Subject: Duke Energy Corporation  
Catawba Nuclear Station, Unit 1  
Docket Number 50-413  
Request for Relief Number 02-003  
Alignment Requirements When Component Inside  
Surfaces Are Inaccessible

Catawba Nuclear Station  
Request for Relief No. 02-003

Request for Relief No. 02-003

Component: Nuclear Service Water Piping (RN System) weld joint 1RN182-33

Figure 1

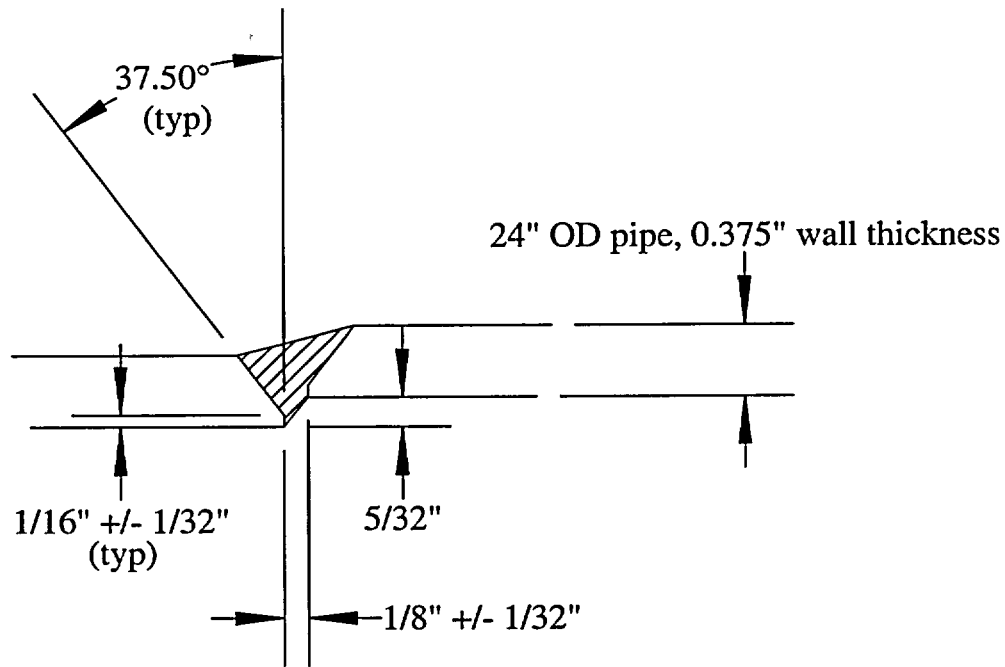
The circumferential butt weld joint 1RN182-33 was installed with a 5/32" mismatch that extended for about 18" around the top of the piping. (See Figure 1.) The internal joint surfaces at the bottom of the piping were flush, ie no observable mismatch. The root pass was made using the GTAW process, the fill passes made using a SMAW process. A slight buildup on the outside surface was faired into the adjacent base metal using a 3:1 taper. Visual and surface examinations were performed on both the root pass and

final pass. This is a Duke Class C, ASME Class 3 weld and is required to meet the requirements of ASME Section III, Subsection ND. In accordance with ND-4233, the maximum allowed mismatch at any one point around the circumference of the welded joint is 3/32".

An engineering evaluation of the existing condition was performed and has demonstrated that the current configuration is structurally acceptable. No changes to the existing joint configuration will be pursued.

Nominal stresses are low at this location primarily due to low deadweight, pressure, thermal and other design loadings. (See Table 1.) Vibrational stresses from normal operation are also low. Changes in stress concentration and stress intensification factors for the mismatch are not significant considering the margin between existing design and allowable stresses. An engineering evaluation has concluded that considering a penalty for the stress raiser (in terms of increased stress indices and an increased stress intensification factor) created by the mismatch, all ASME III, ND 3600 design requirements remain satisfied.

Consideration of repair was performed but rejected since the residual stresses from a forced fitup may counteract reduction in stresses from an elimination of stress concentration effects. Temporary welded attachments are typically used to force the circumferential shape necessary to achieve fitup. Residual stresses are developed in the joint after completion of the weld as the load is removed from these

attachments. In this particular case, these residual stresses may be more detrimental than the stress concentration effects from the mismatch.
